PCN# 20141003000
Conversion to smaller reel (13" to 7") and associated packing materials
on selected products currently shipped in 13" reels
Information Only

Date: 10/7/2014
To: Newark/Farnell PCN

PCN Number:	20141003000	PCN Date:	10/07/2014
--------------------	-------------	------------------	------------

Title:	Conversion to smaller reel (13" to 7") and associated packing materials on selected products currently shipped in 13" reels
---------------	---

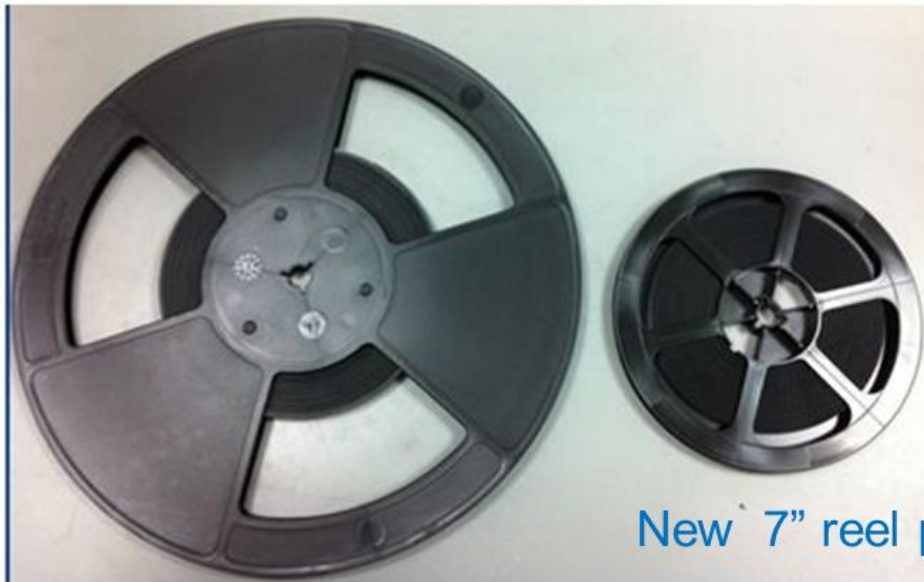
Conversion to a smaller reel size for selected product currently shipped in 13" reels with small reel quantities (250ea). The Moisture Barrier Bag (MBB) and pizza box will be switched to accommodate the smaller reel size. All new packing materials are qualified and currently in use for other products.

From	To
Reel Diameter	13"	7"
Pizza Box	4041330	4206831
MBB	4209534-0001 / 4200734-0001	4209534-0005 / 4200734-0025

Reason for Change:			
Quality improvement due to reported deformed reel.			
Anticipated impact on Fit, Form, Function, Quality or Reliability (positive / negative):			
None			
Changes to product identification resulting from this PCN:			
Product will be shipped in smaller (7") Reels and packing materials			
Product Affected:			
ADS42JB46IRGC25	CC2567RVMT	CC430F5147IRGZT	PAIC3000IRGZT
ADS42JB49IRGC25	CC2569RVMT	CC430F6125IRGCT	SN1108041RHRT
ADS42JB69IRGC25	CC430F5123IRGZT	CC430F6126IRGCT	TLV320AIC29IRGZT
ADS42LB49IRGC25	CC430F5125IRGZT	CC430F6127IRGCT	TLV320AIC29IRGZTG4
ADS42LB69IRGC25	CC430F5133IRGZT	CC430F6135IRGCT	TLV320AIC3000IRGZT
ADS5263IRGCT-NM	CC430F5135IRGZT	CC430F6137IRGCT	TLV320AIC3005IRGZT
BL6450QRVMT	CC430F5137IRGZT	CC430F6143IRGCT	TLV320AIC3106IRGZT
CC2430M128RTCT	CC430F5143IRGZT	CC430F6145IRGCT	TLV320AIC33IRGZT
CC2430ZF128RTCT	CC430F5145IRGZT	CC430F6147IRGCT	TLV320AIC33IRGZTG4
